STATE OF NORTH CAROLINA
DEPARTMENT OF TRANSPORTATION

Subject: **Request for Section 401 Modification** for US 1 Vass Bypass, Moore/Lee County; TIP No. R-0210WM; Federal Aid No. NHS-1 (108); State Project No. 6.569005T; Division 8; Debit \$475.00 from WBS 34330.4.3.

Attachment A - Summary of Emergency Spill Control Measures and Devices - Location and Site Identification
TIP No. R-210 WM

TYPE OF WORK: STORMWATER DEVICES

PROJECT REFERENCE NO.		SHEET NO.	
R-0210WM		15	
R-0210A		22	
ROADWAY DESIGN ENGINEER		HYDRAULICS ENGINEER	
CONST. REV.			
R/W REV.

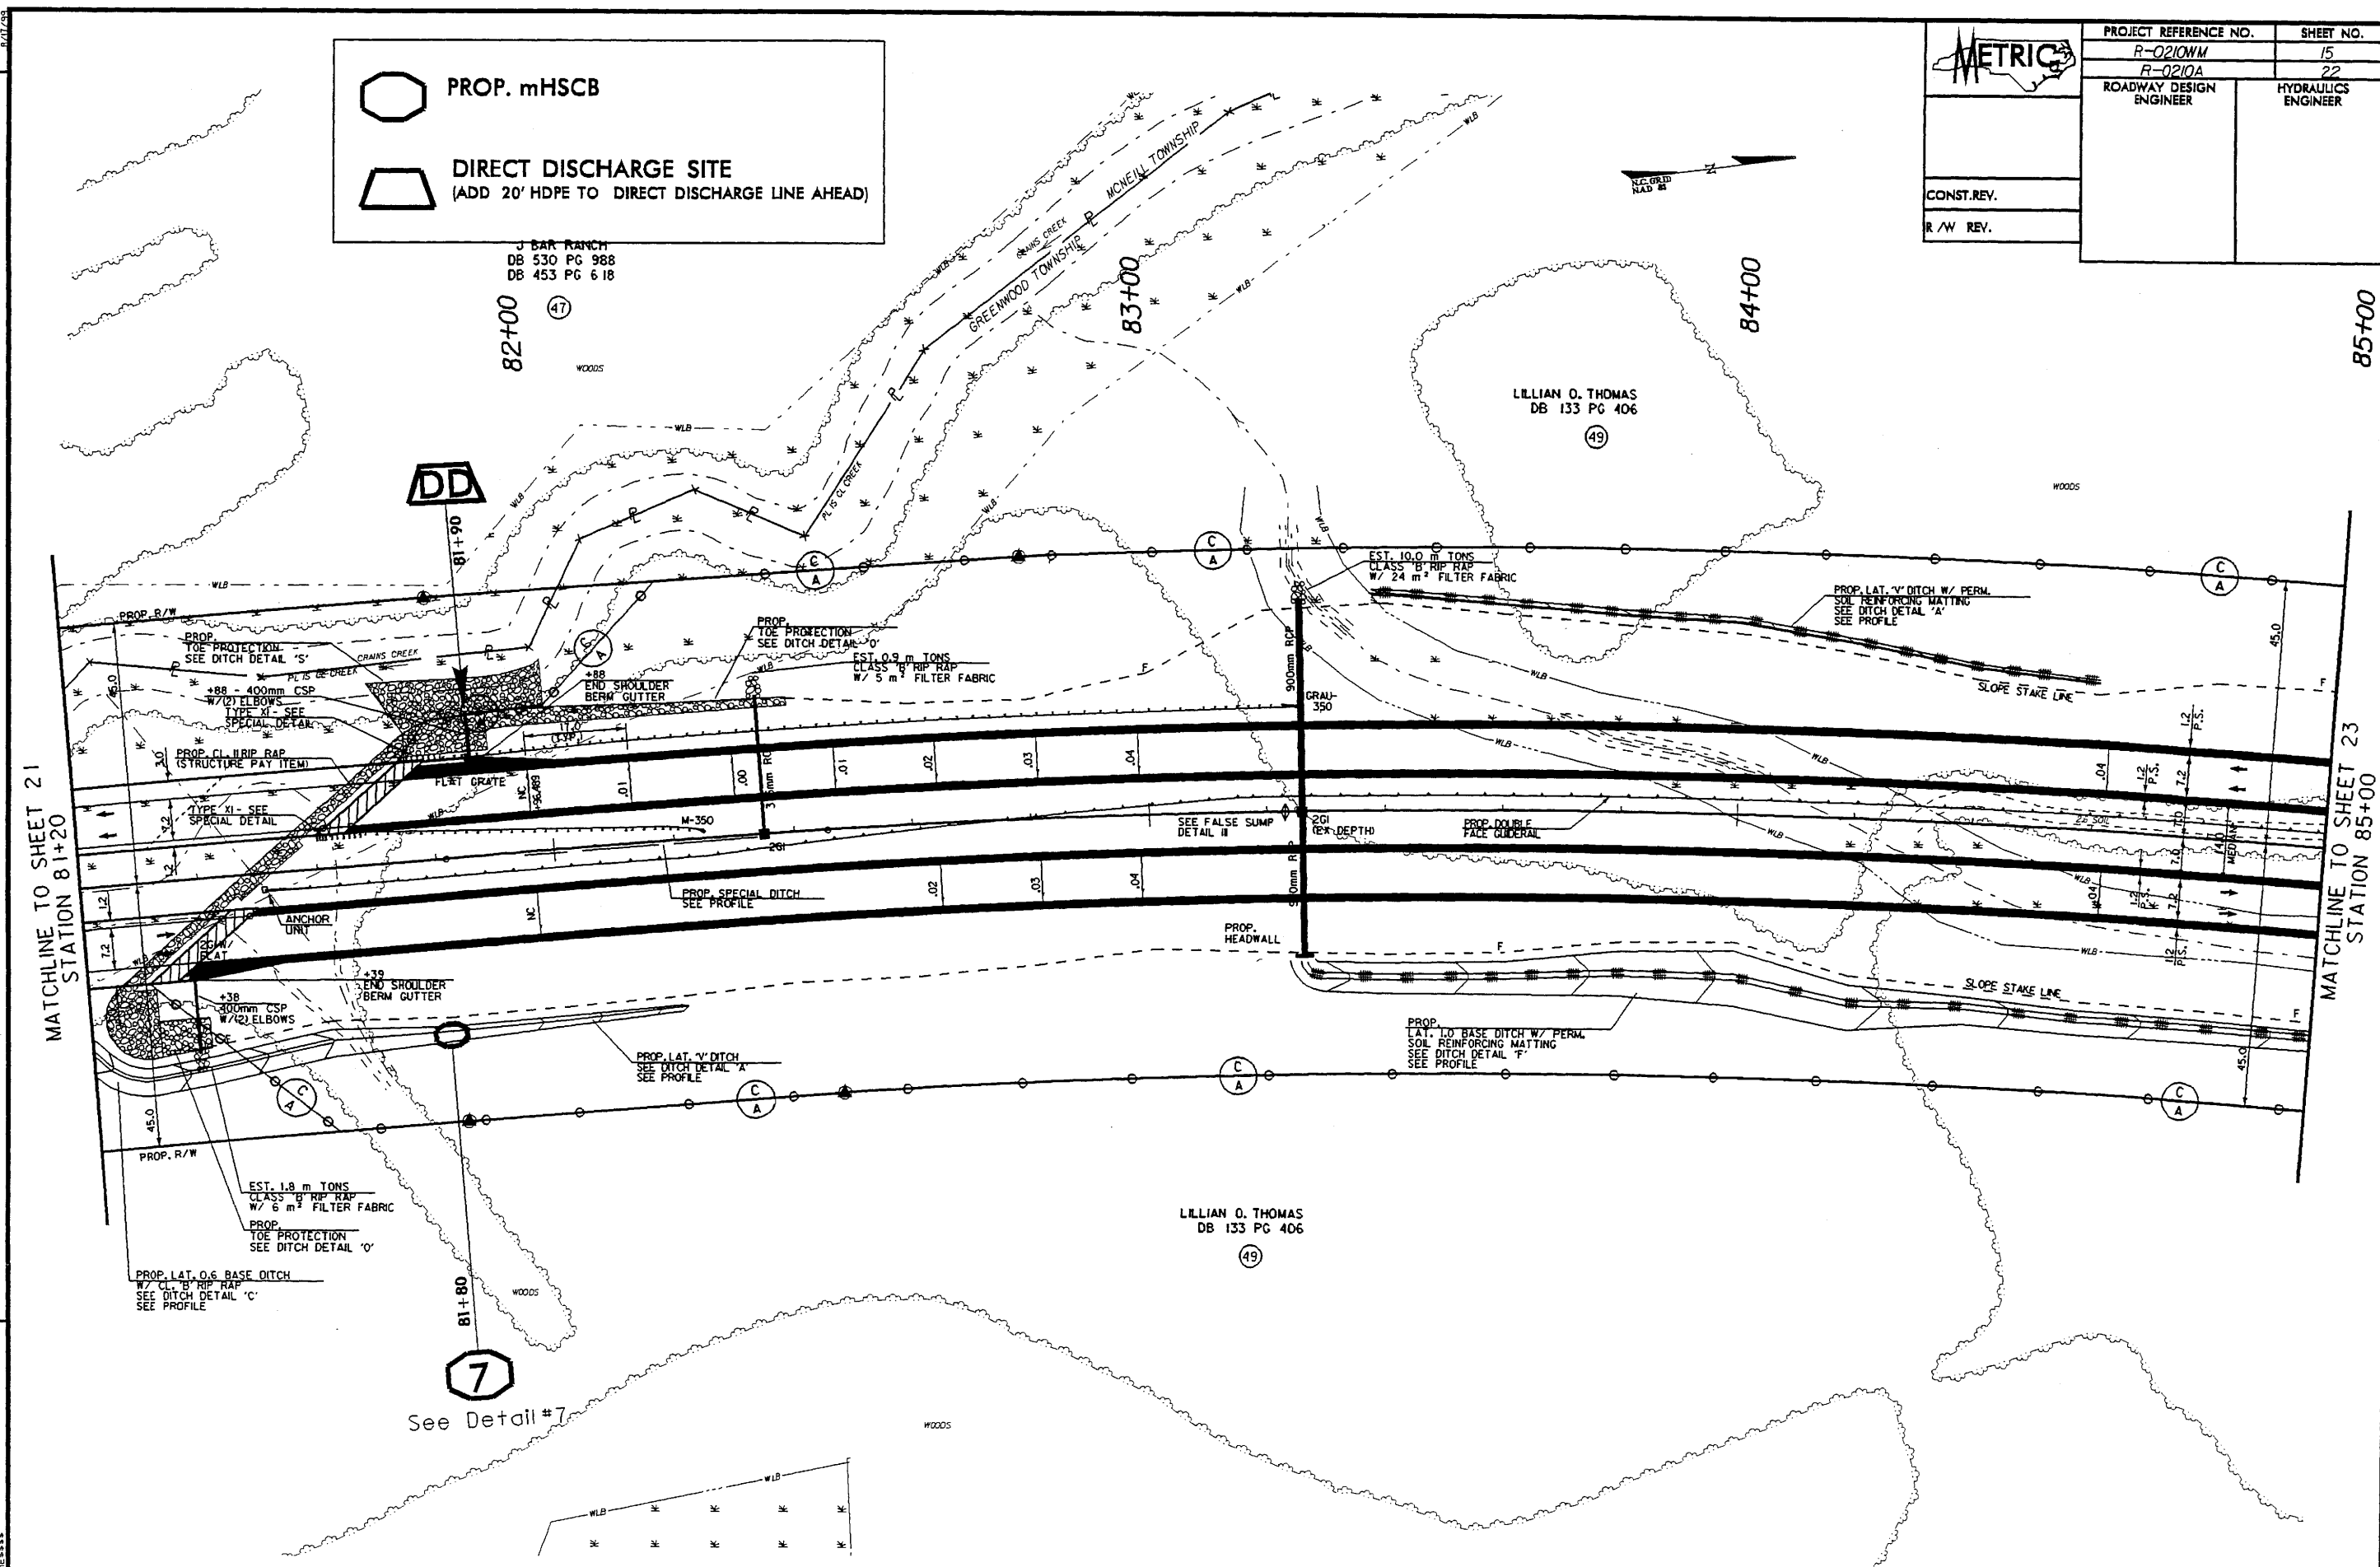
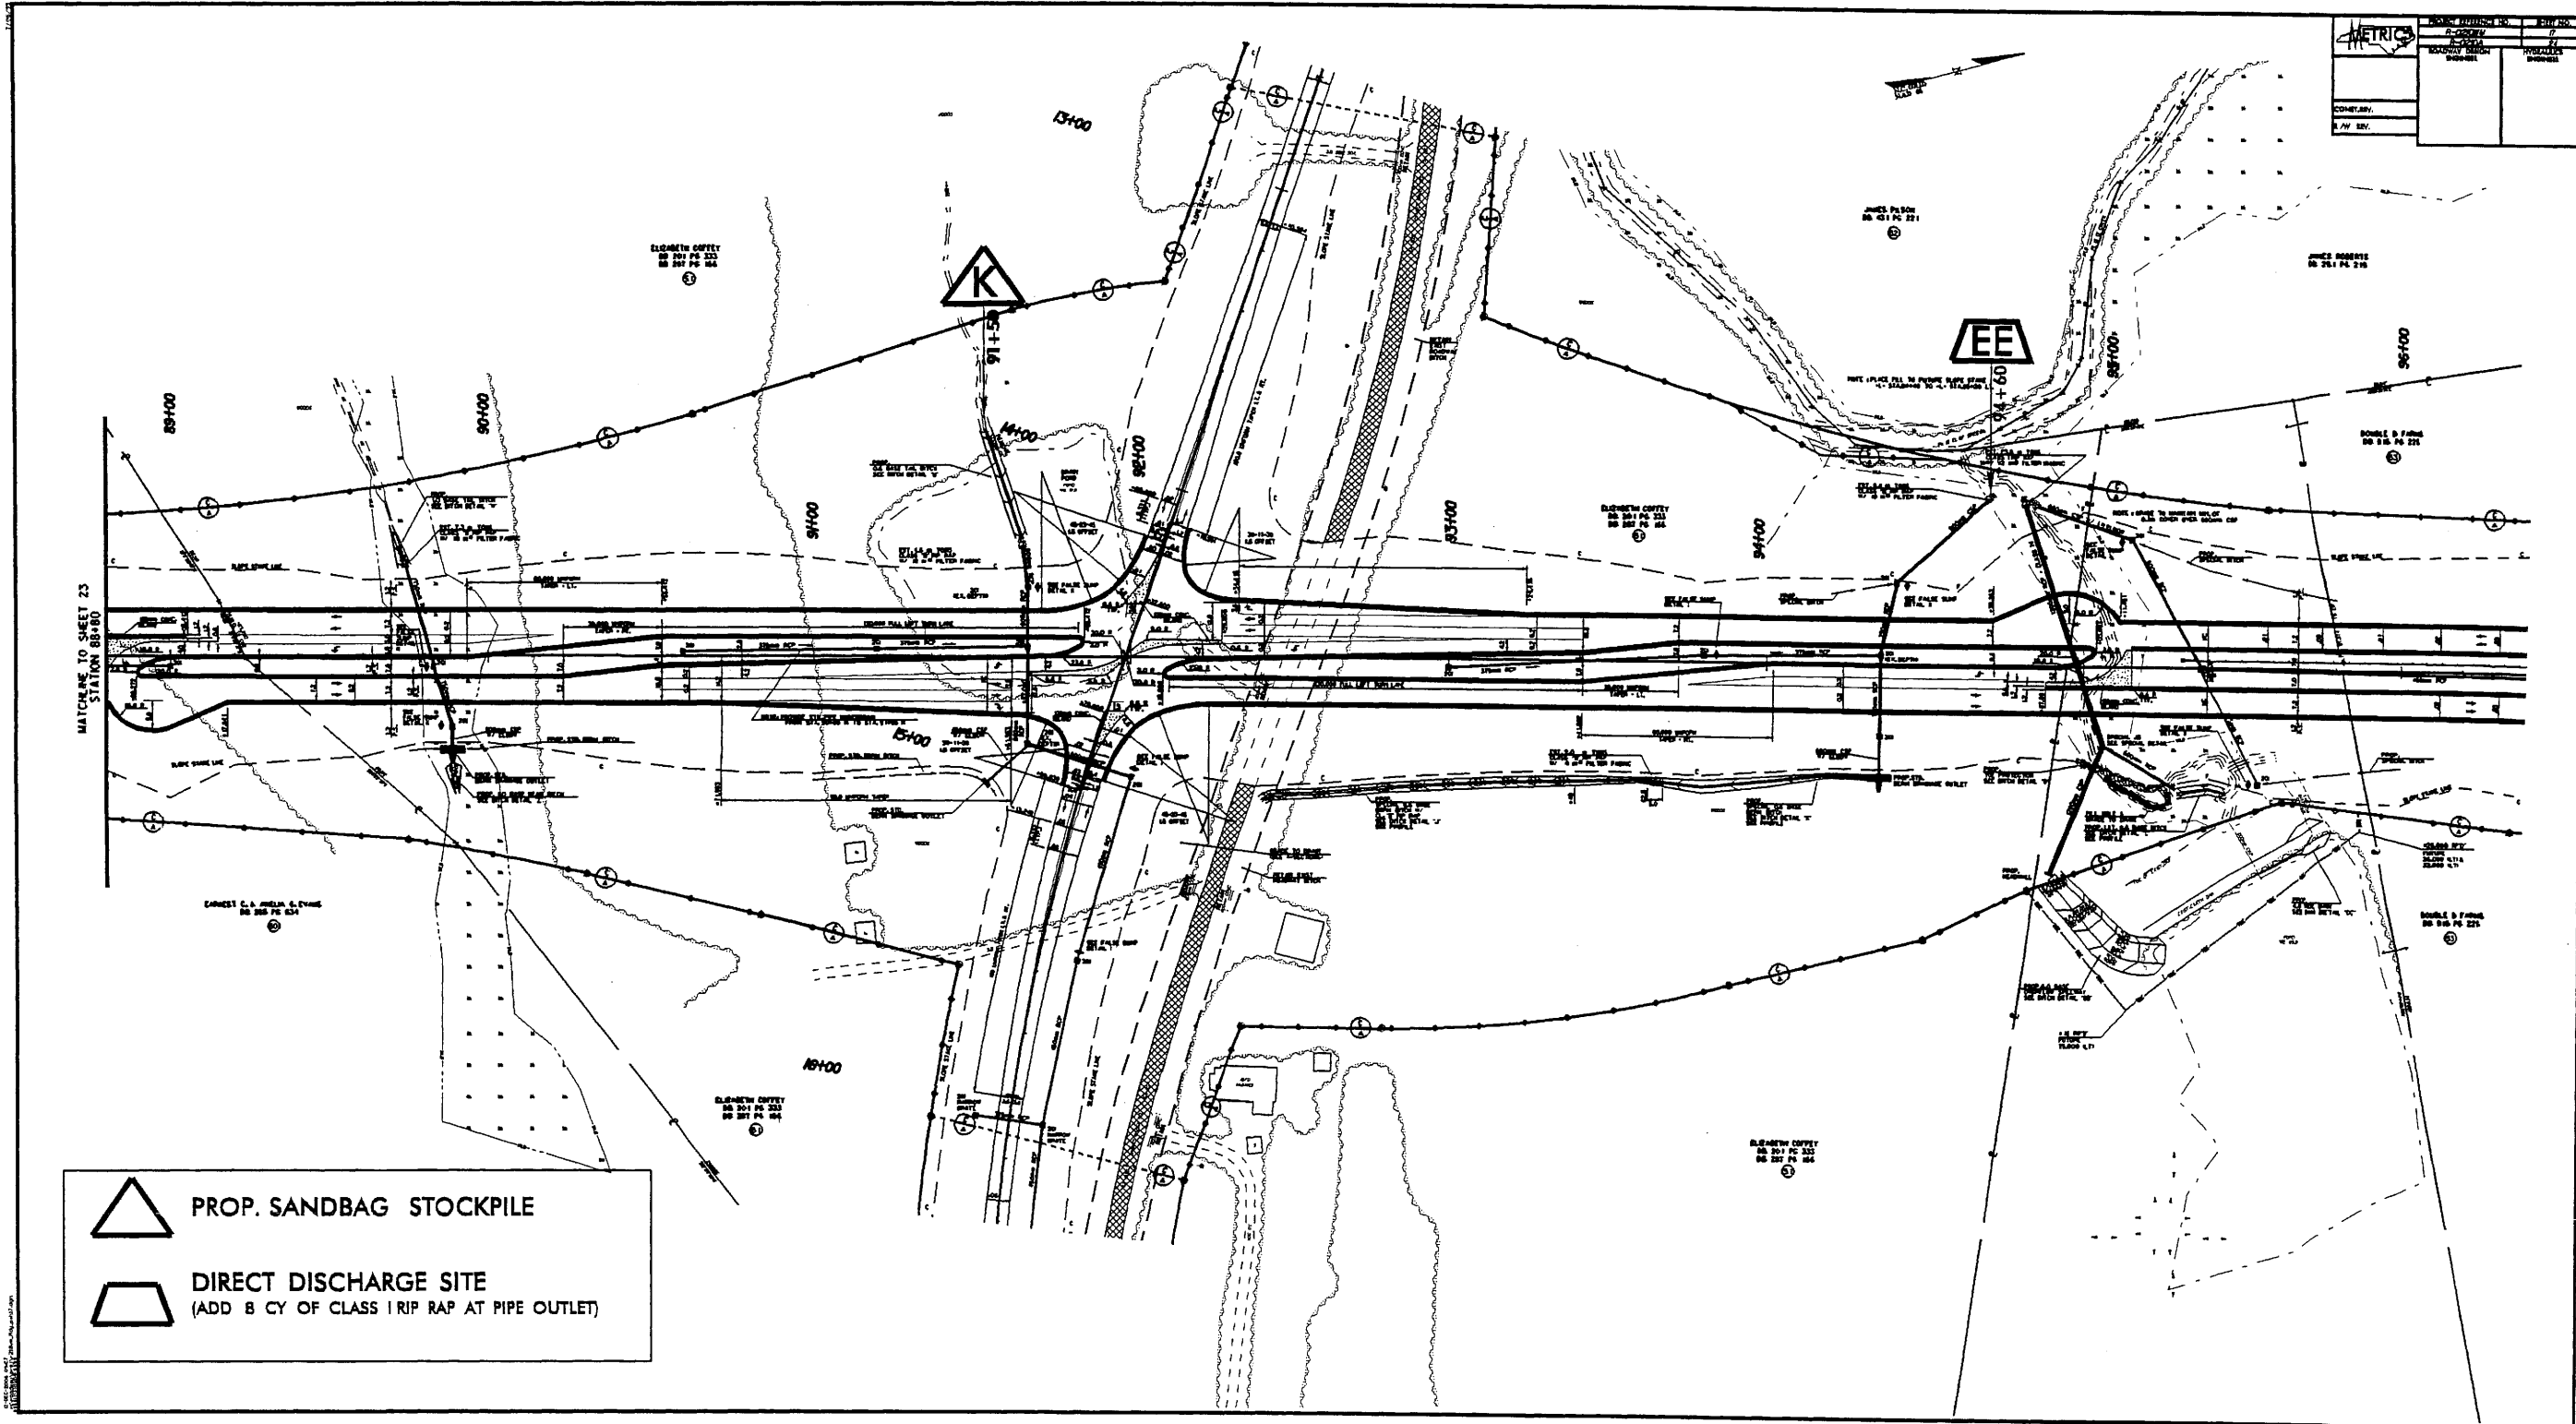
- At Station No. 81+90 Left (Site DD) on Sheet 15 of TIP No. R-210WM, the NCDOT will eliminate this direct discharge adding 20 feet of high density poly ethylene (HDPE) to the existing pipe. This will allow discharge outside the buffer. Notes have been included on the plan sheet to describe this work.

PROP. mHSCB
 DIRECT DISCHARGE SITE
 (ADD 20' HDPE TO DIRECT DISCHARGE LINE AHEAD)

- At Station No. 94+60 Left (Site EE) on Sheet 17 of TIP No. R-210WM, the NCDOT will place additional Class I rip rap at the outlet of the 36-inch RCP to deflect flow away from opposite stream bank. Notes have been included on the plan sheet to describe this work.

PROP. SANDBAG STOCKPILE
	DIRECT DISCHARGE SITE (ADD 8 CY OF CLASS 1 RIP RAP AT PIPE OUTLET)
